# SEQUENTIAL ECR

ECR NO. 739  
SHT. 2 OF 6

TY11UEN035  
PC2400-3  
REV A

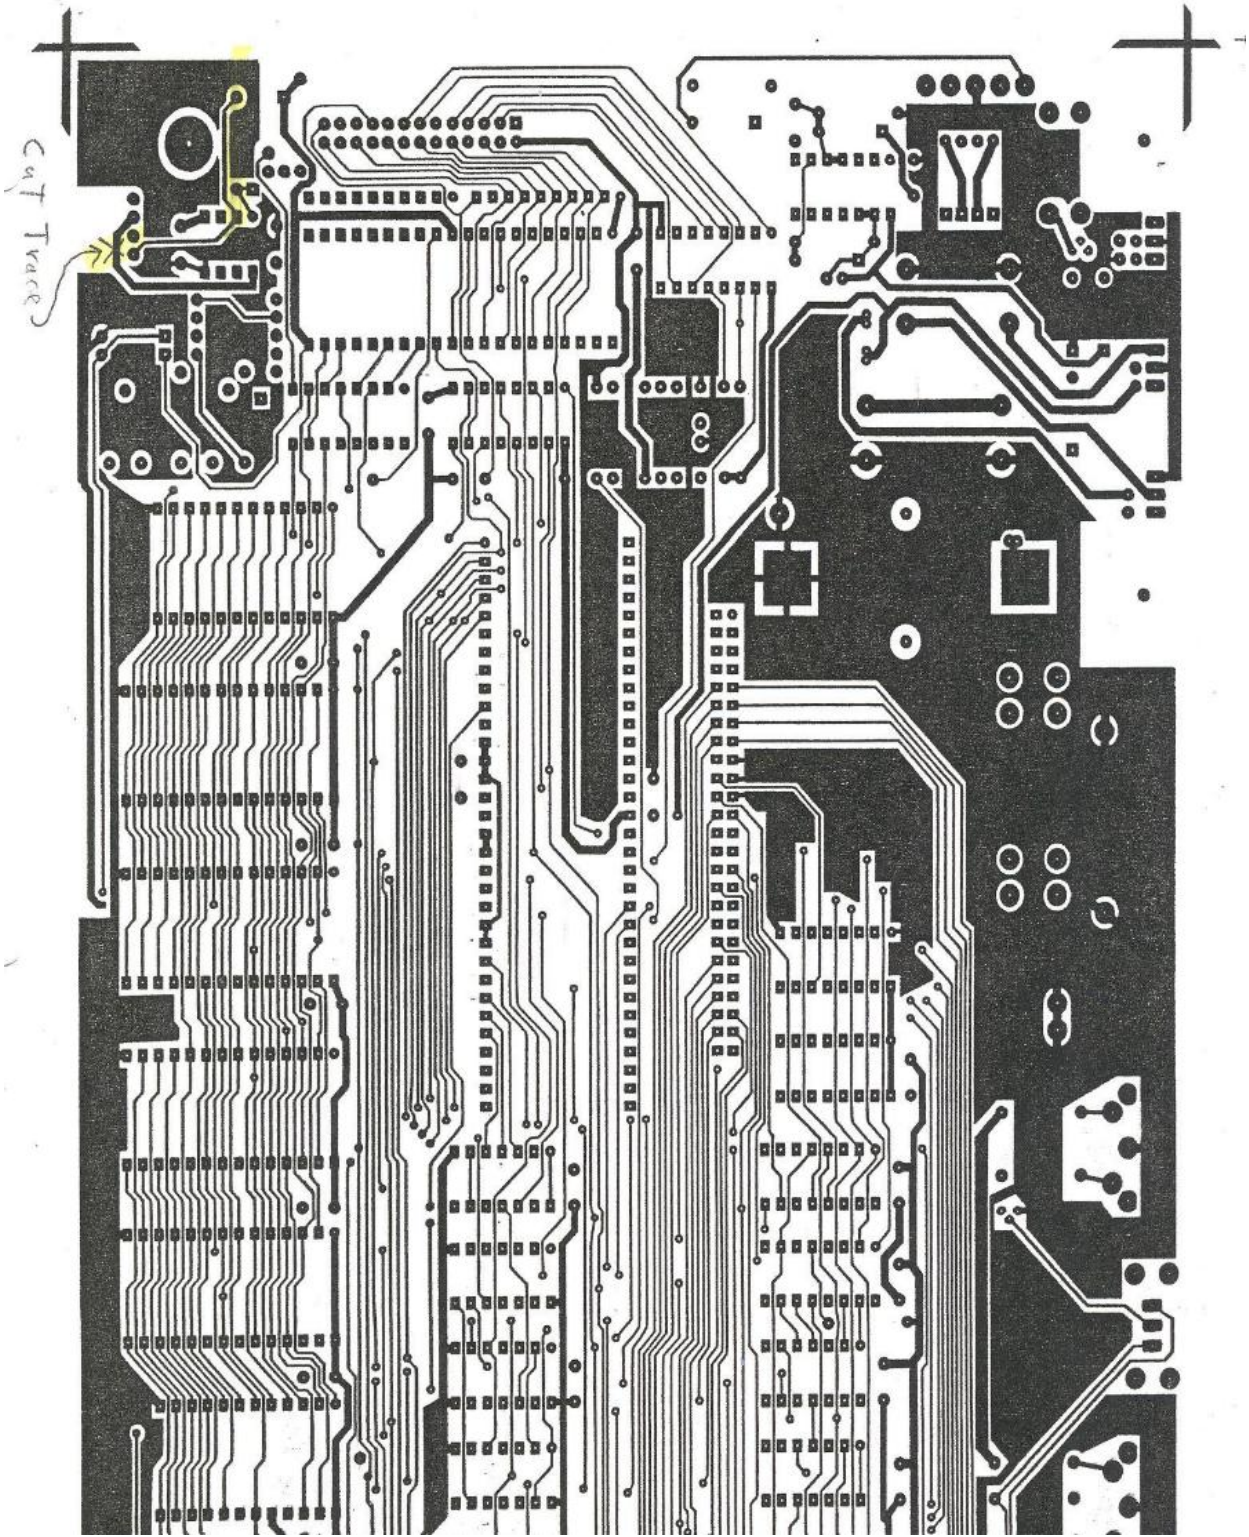
1. Cut The Two Traces connecting J306 pin 1+2 To +12V					
2. Jump from U310 pin 8 To lower leg of Offset Trimmer					
3. Add 6.8K (R-079) from +12V To J306 pin 1+2

4. Add 1K (R-008) from ground To J306 pin 1+2					
5. Change R304 from 2K (R-010) To 15K (R-014)					
DOCUMENTS AFFECTED
